CENTERVILLE CITY PLANNING COMMISSION AGENDA

Short Title: Public Hearing - Conceptual Site Plan Amendment - RB's Gas Station

**STAFF REPORT
AGENDA: ITEM 1**

PROPERTY: **RBs ONE STOP
219 WEST PARRISH LANE**

ELEVATION VIEW
SCALE: 1 1/2"=1'-0"

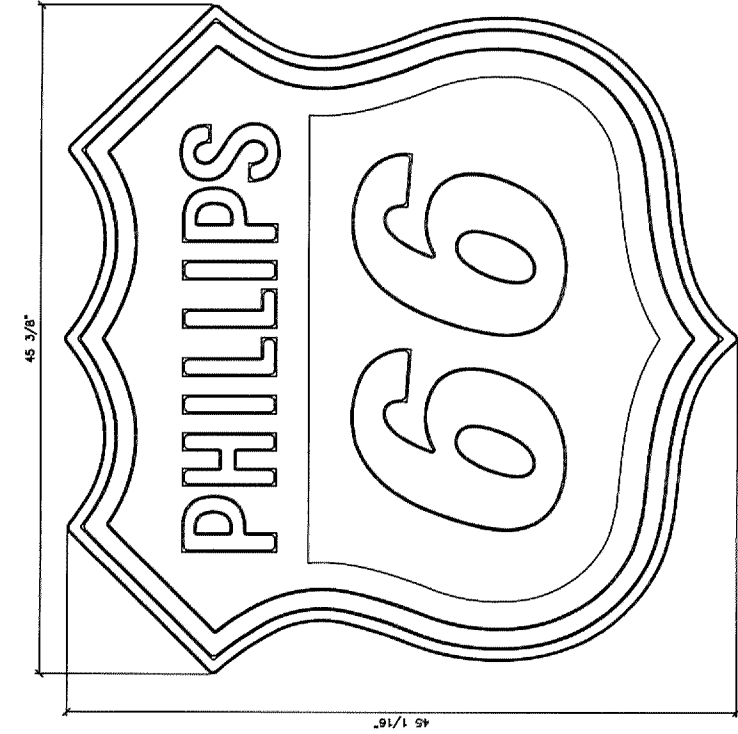
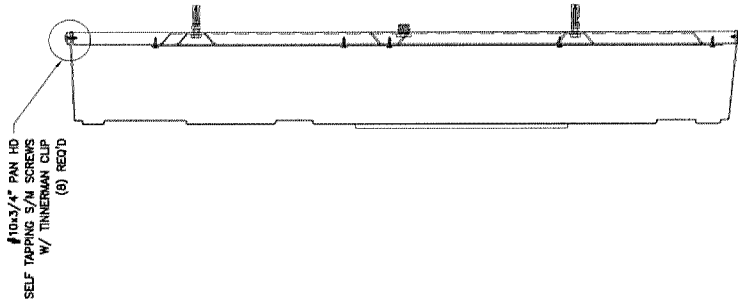
STAFF COMMENTS –Staff finds the proposed signs on the canopy to exceed the top height of the canopy and should be shrunk, or lowered to not go above the top of the canopy.

1. *The applicant shall prepare and submit a Final Site Plan Amendment Application, as described by the Zoning Ordinance.*
2. *The signs on the canopy shall be modified to comply with CZC 12.54.060.i.*

CANOPY PERSPECTIVE

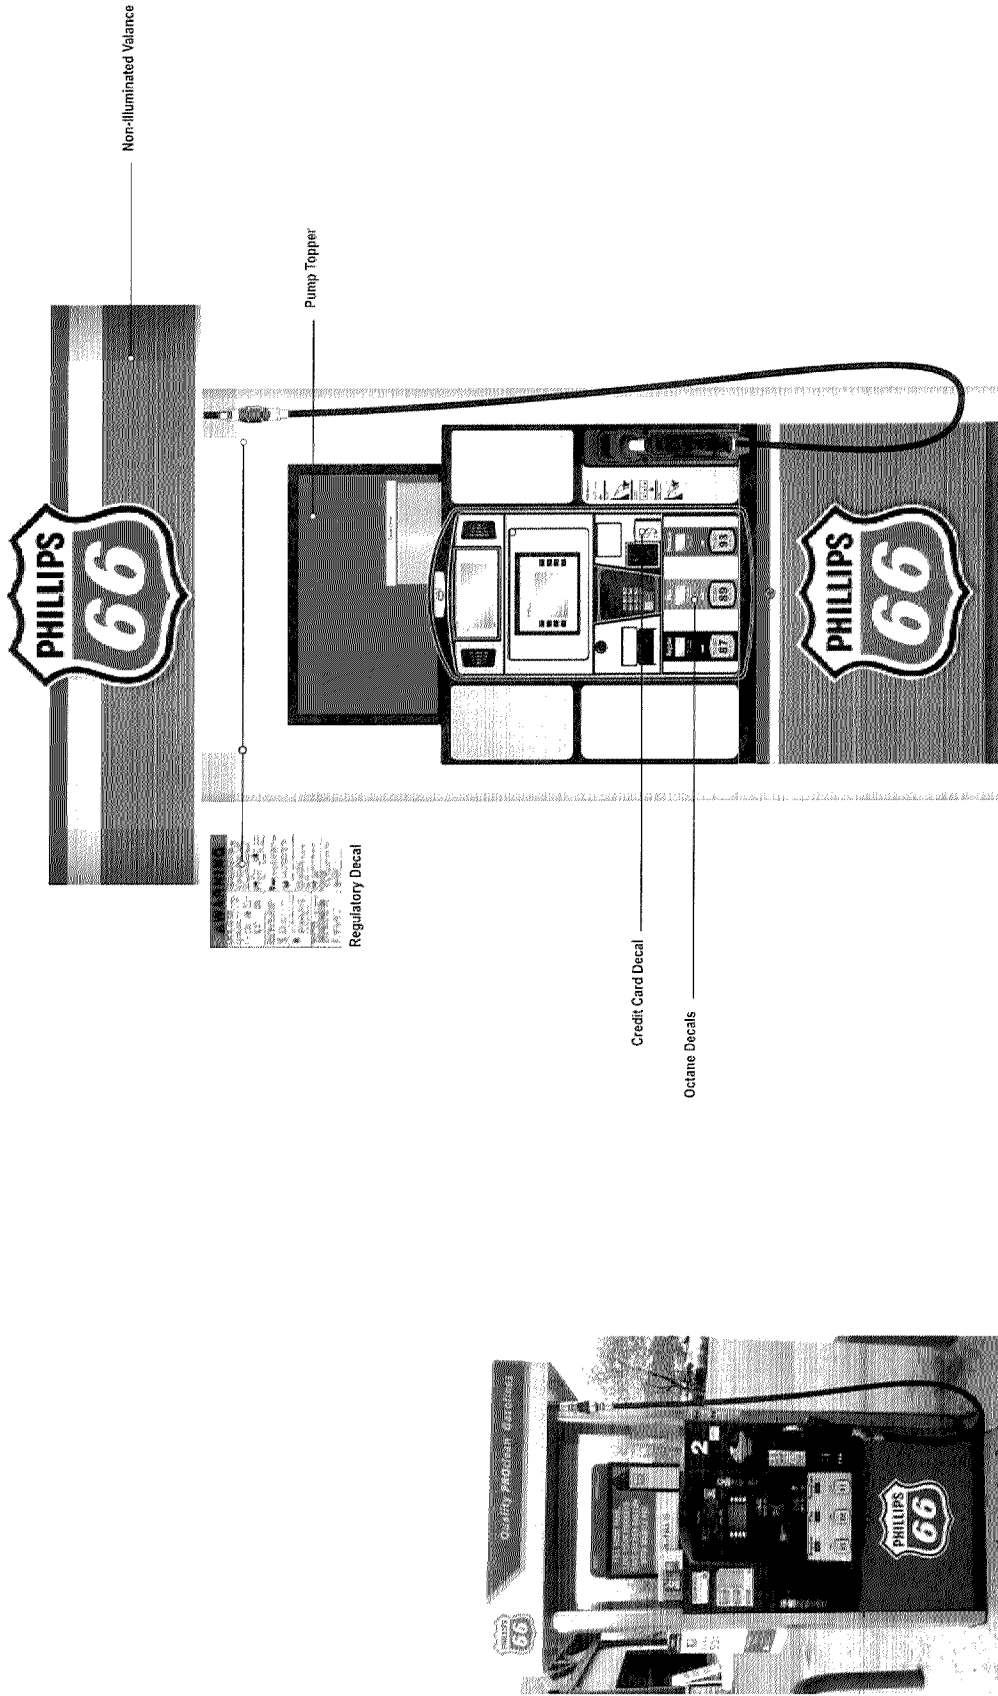
STAFF COMMENTS – It is important to note CZC 12.43.010 “It is not the purpose or intent of this Chapter to regulate the message or content displayed on any sign.” The applicant is proposing color changes to the canopy, and sign poles, which the City can regulate, but the City does not regulate the content/color scheme of the sign itself. Staff believes the sign color scheme matches a similar canopy found at Sonic across Parrish Lane.
